21 July 2016

DEXUS QUARRYWEST PROJECT (SSD 6801) – SECTION 96 MODIFICATION (MOD 2) – STATEMENT OF ENVIRONMENTAL EFFECTS

Figure 2: QuarryWEST Masterplan – As Currently Approved

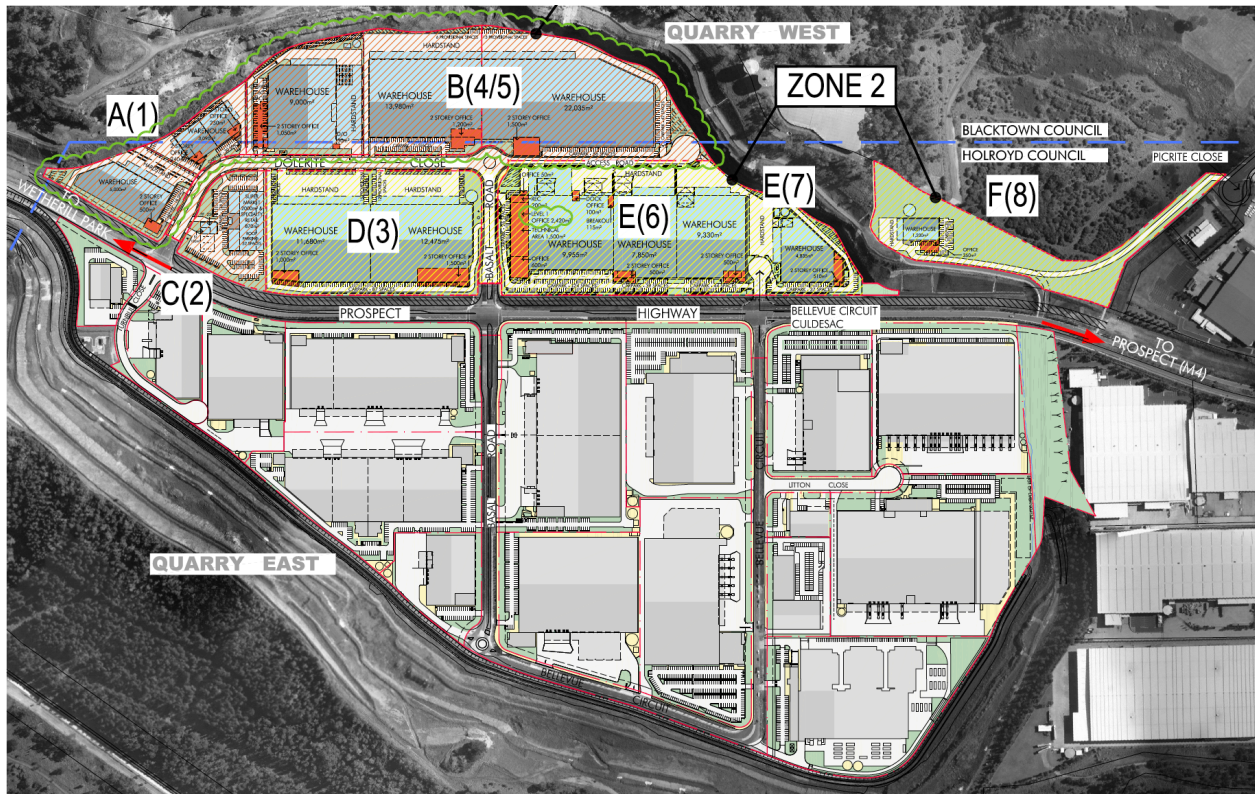
The development consent has been modified once since the original approval. The modification involved some relatively minor changes to the layout of the facilities in Precincts A, B and E, and was approved by the DP&E on 16 June 2016. The modified estate masterplan is shown on **Figure 2**.

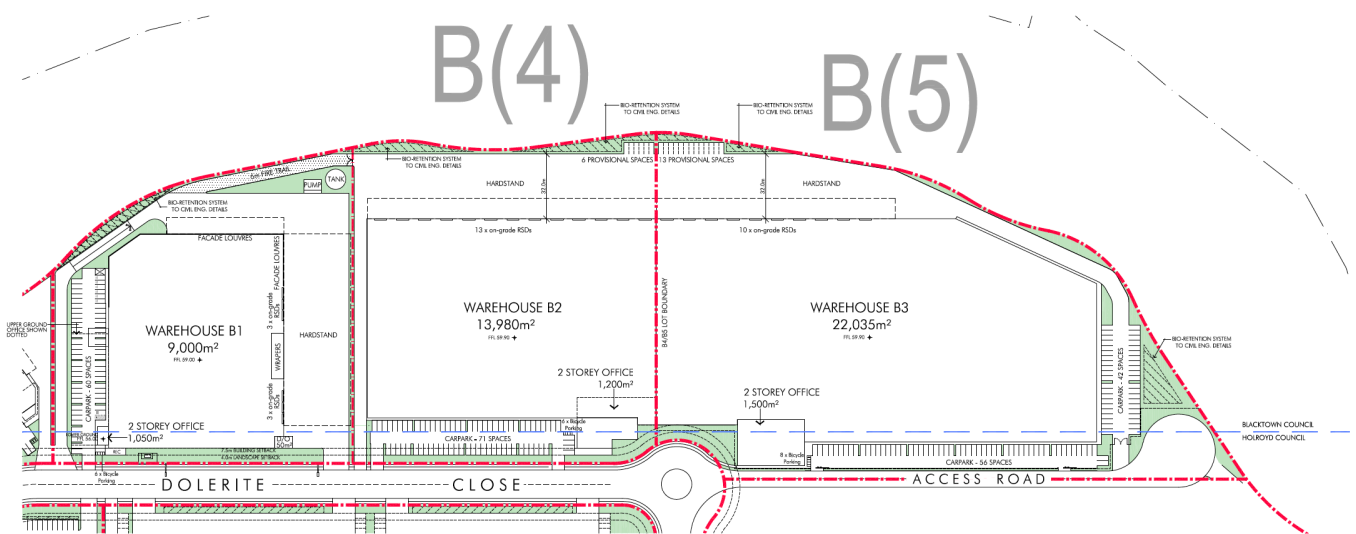
Detailed design for the remaining facilities in Precinct B (ie. Warehouses B2 and B3) has identified the need for some relatively minor changes to the approved layout of these facilities (the approved layout of Precinct B is shown on **Figure 3**).

DEXUS proposes to modify the development consent for the QuarryWEST Project to amend the internal masterplan layout in Precinct B. The changes involve alterations to the layout of Warehouse B2 and Warehouse B3, including:

The site plan illustrates the layout of the proposed industrial development. It features three main warehouse units: Warehouse B1 (9,000m²), Warehouse B2 (13,970m²), and Warehouse B3 (20,050m²). Each warehouse is accompanied by a 2-storey office building. The plan also shows various parking areas, including a 200-space parking lot, and service roads like Dolerite Way and Access Road. Key infrastructure elements include a 6m fire tank, a 10m fire tank, and a 10m fire tank. The plan also shows a 10m fire tank, a 10m fire tank, and a 10m fire tank. The plan also shows a 10m fire tank, a 10m fire tank, and a 10m fire tank.
